REMARKS

This Amendment is submitted in response to the Office Action dated March 15, 2001. In the Office Action, the Examiner rejected claims 1-23. With this Amendment, new claims 24-43 are added; no claims are canceled; and claims 3, 4, and 10 are amended. Upon entry of this Amendment, the above-identified application will include claims 1-43.

Fig. 8

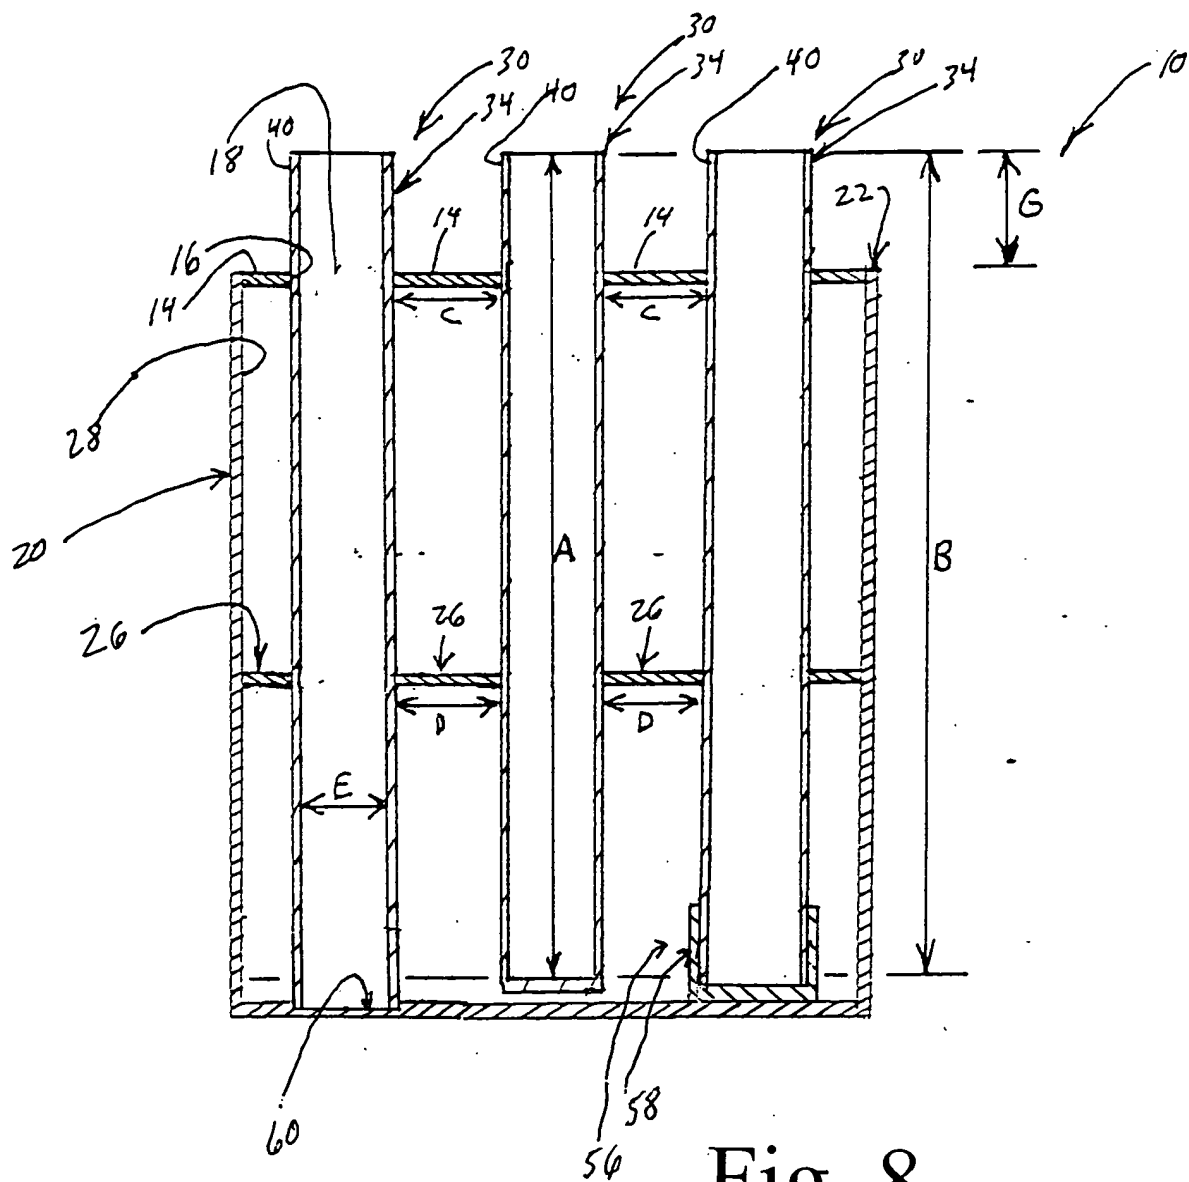
In the Office Action, the Examiner objected to the drawings under 37 C.F.R. § 1.83(a). In support of this objection, the Examiner stated:

“The drawings are objected to under 37 CFR. 1.83(a). The drawings must show every feature of the invention specified in the claims. Therefore, the spacing structure, recesses, sockets, first spacing component, second spacing component, and legs must be shown or the feature(s) canceled from the claim(s). No new matter should be entered.”

"The specification is objected to as failing to provide proper antecedent basis for the claimed subject matter. See 37 CFR 1.75(d)(1) and MPEP § 608.01(o). Correction of the following is required: shells, spacing structure, recesses, first spacing component, second spacing component."

described in the specification as permissibly being the legs of concern to the Examiner. (See page 5, lines 16-21 and lines 25-27 of the above-identified application). Finally, Applicant has added new Figure 8 that depicts the recesses of concern to the Examiner at 60 and the sockets of concern to the Examiner at 58.

Then, Applicant directs the Examiner's attention to new Figure 8 and the amended paragraph added in place of the original paragraph at page 13, lines 3-14, where details about the recesses and sockets are provided. Applicant notes that details about these recesses and sockets were also provided in the first paragraph on page 13, at lines 3-14, of the above-identified application, as originally filed.

--Figure 8 is another sectional view of the ice fishing tackle storage apparatus depicted in Figure 3, taken through line 3-3.--

As another option, a positioning flange[s (not shown)] 56, such as a socket[s (not shown)] 58, that [are] is capable of accepting and securing the distal ends 38 of the tubes 30, as best depicted in Figure 8, may be fixed to the bottom wall 25 of the container 12, in lieu of the template 26, when the template 14 is used. The flange[s] 56, in combination with the template 14, helps to stabilize and maintain a particular desired alignment between different tubes 30. As another alternative, the templates 14, 26 may each be dispensed with, in favor of [the] positioning flanges 56 or sockets 58 only, by increasing the height of the positioning flanges 56 or sockets 58 to grip more of the length of the tubes 30. As yet another alternative, a recess[es (not shown)] 60 may be bored or formed in the bottom wall 25 of the container 12 to accept the distal ends 38 of the different tubes 30, in place of using the positioning flanges 56 or the template 26 for purposes of stabilizing the tubes 30.
